Groundwater & Wastewater Services
Septic Project File & Data Review Worksheet

MECKLENBURG COUNTY
Health Department

Re: Application for improvement permit for:
Property Site: 13208 Allison Ferry Road
Health Department file number: **8578B**

SOIL/SITE EVALUATION for ON-SITE WASTEWATER SYSTEM

Sketch of Soil Evaluation Locations

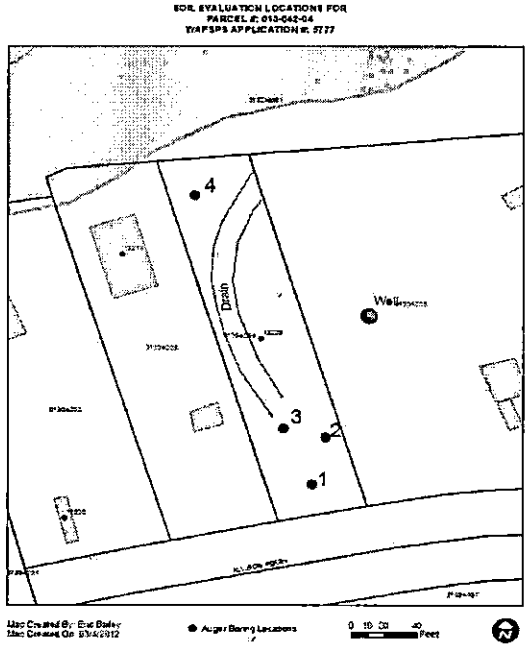
Description	Initial System	Repair System
Available Space (.1945)	US	US
System Type(s)		
Site LTAR	0.275	0.275

Other Factors (.1946):
Soil Evaluation By: Eric Bailey LSS
Others Present:
Site Classification (.1948): UNSUITABLE
Site Evaluation By: Jeremy Michelone, REHS
Others Present: John Todd
